STAFF RECOMMENDATION
945 S Douglas Avenue, Unit #6
June 16, 2021

Application: New Construction – Infill/Part II SP
District: Waverly-Belmont Neighborhood Conservation Zoning Overlay
Council District: 07
Base Zoning: SP
Map and Parcel Number: 105130289.00
Applicant: Martin Wieck, Nine12 Architects
Project Lead: Jenny Warren, jenny.warren@nashville.gov

Description of Project: This is an application for the construction of an infill structure as part of a part II historic review of an SP zoning.

Figure 9. Roof plan

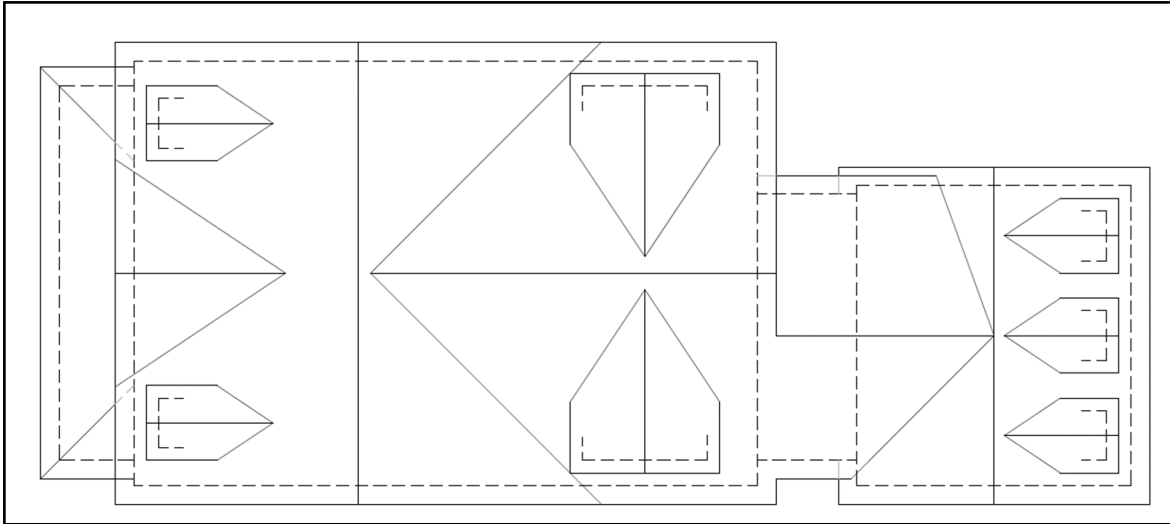
Roof Shape: The design incorporates a primary side facing gable with a 12/12 slope and steeper front and rear-facing gables. There are appropriately inset gabled dormers on the front, side and rear elevations. Staff finds that this side-gabled roof form contributes to the variety of forms on the site, which the Commission had requested as a part of the initial SP approval. However, as discussed above, staff finds that the front-facing gable roof pitch is too steep and not characteristic of the neighborhood.

With the condition that the front facing gable and dormers be reduced in pitch, to no more than 12/12, staff finds that the proposal meets section V.B. for Form.

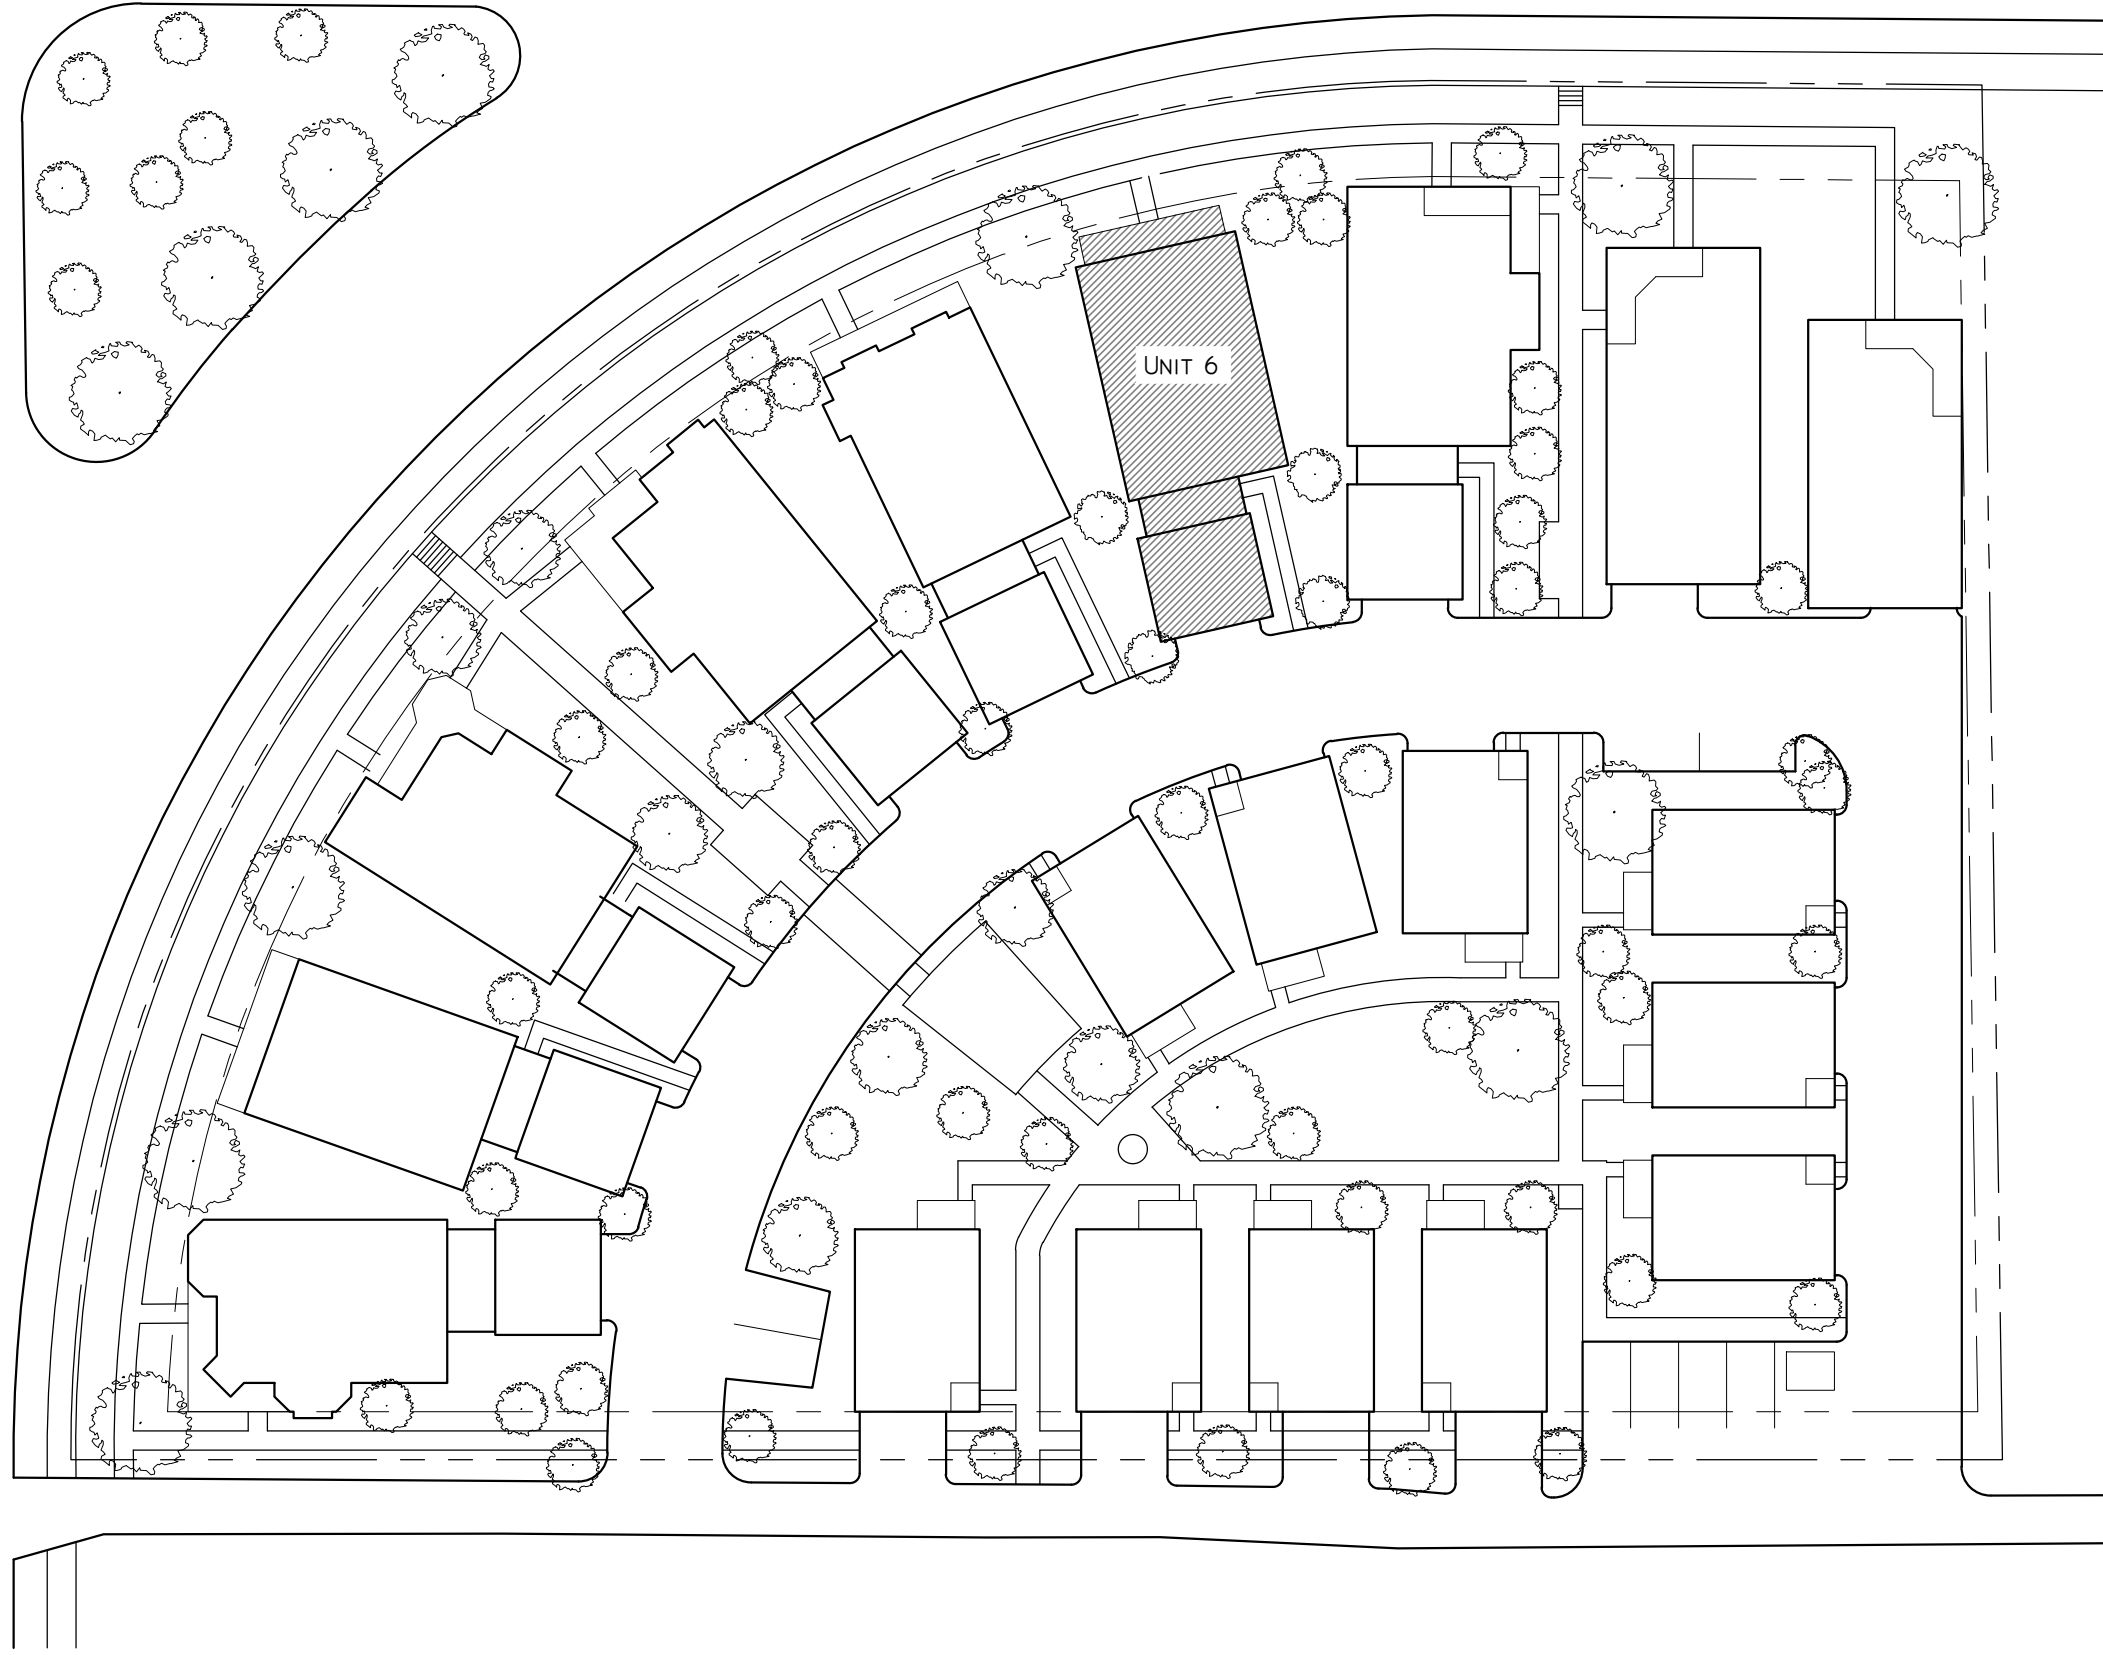
The applicant was encouraged to use multiple roof forms across the development to create variety and avoid a homogenous streetscape. The main roof form presented for this unit is a side-gable with front-gabled dormers. This is an appropriate historic form. However, staff finds that the steep 18/12 pitch of the front-facing gable and dormers,

along with the Victorian/gothic detailing, creates a gothic style not seen elsewhere in Waverly-Belmont. The guidelines specify that “*residential roof pitches of the main form of a building are between 6/12 -12/12*”. The Commission approved a 20/12 slope for a Tudor-style house for Unit #4, but Tudor style homes are more common in this neighborhood, while this type of gothic detailing is not. The Waverly Place National Register nomination notes that the Victorian-era styles, the third most common in the district, are Queen Anne, Eastlake, and ones with simple vernacular detailing. Staff is concerned that the overall development could end up as a collection of replicas of different historic styles, not all of which are actually found in the neighborhood. Part II of the design guidelines (II.F) encourages new construction inspired by historic styles and discourages replicas. The Secretary of Interior Standards, on which the design guidelines are based and that are included in section I.D. states that new construction should be of its own time and not create a “false sense of historical development.”

With the condition that the front-facing gable and dormers are reduced in pitch to not exceed 12/12, staff finds that the project meets sections V.A. and B. for Massing, Scale and Form.

SITE
PLAN

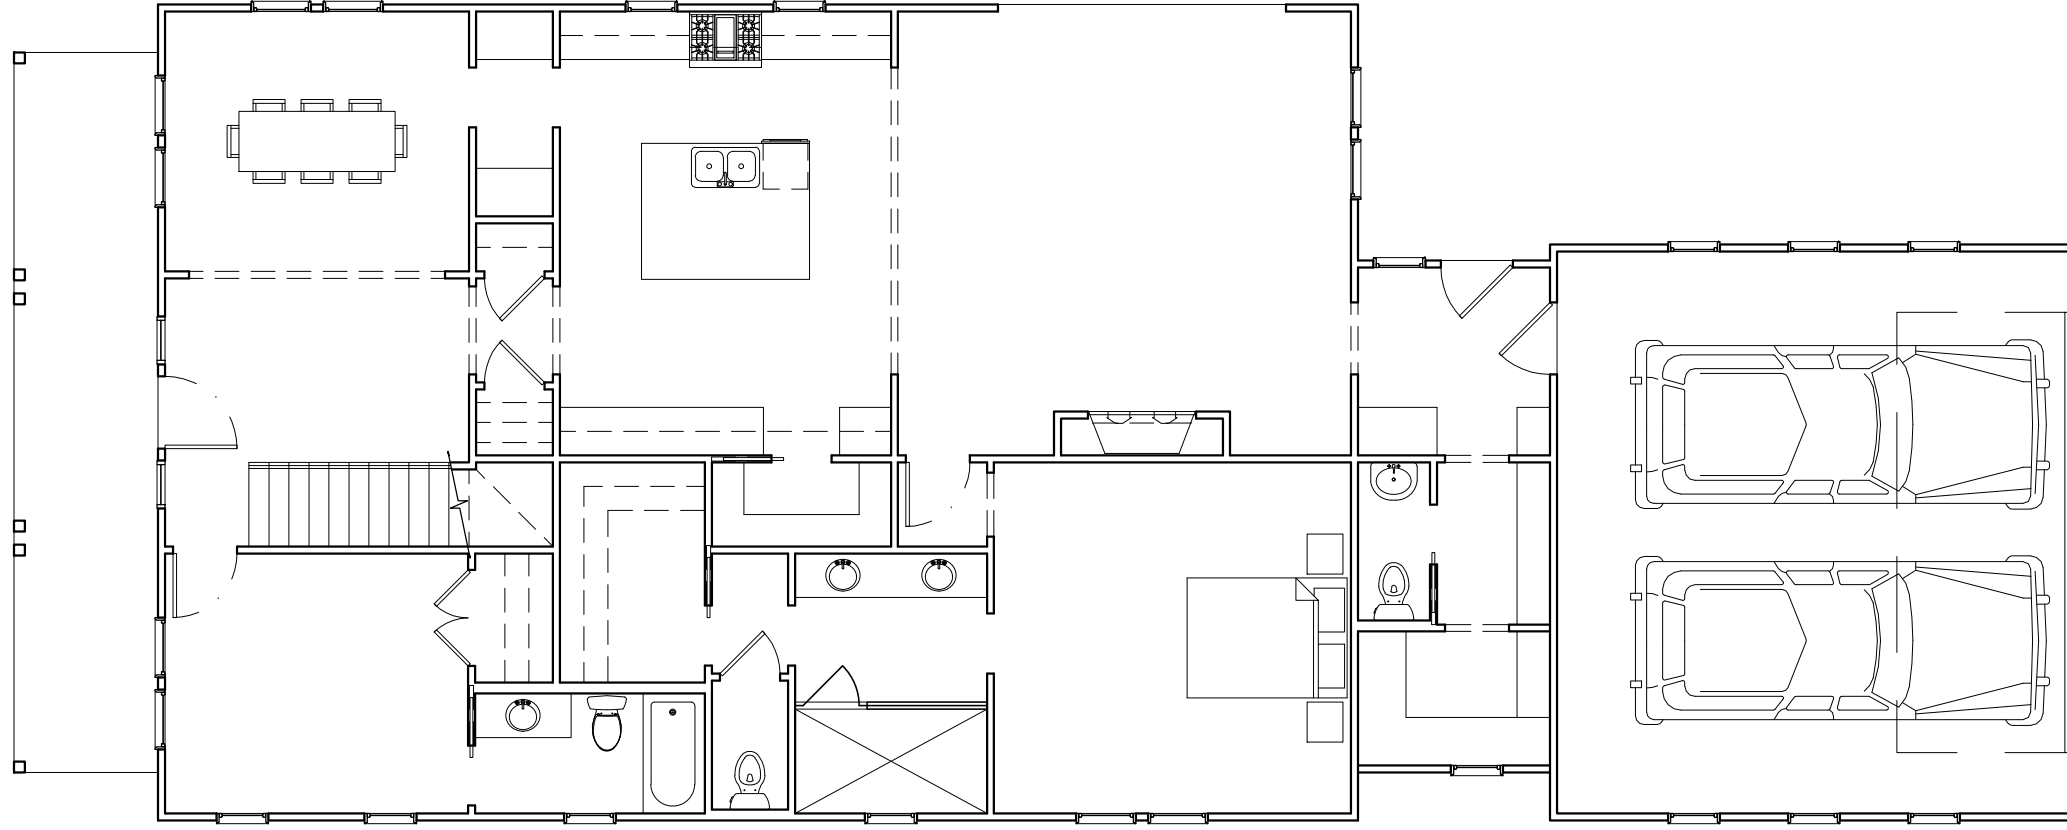
Setback & Rhythm of Spacing: The infill will be sited as per the approved part I SP. (Figure 1) This house will have a twenty-foot (20') front setback, as do all of Units 1-7. These houses will mostly be about twenty-five feet (25') apart at the front and will come closer further back, due to the curve of the parcel.

Unit #6 will be about twenty-four feet (24') from both Units #5 and #7 at the front will be about twelve to thirteen feet (12'-13') from these neighboring houses at the back corners. This is consistent with the SP site plan.
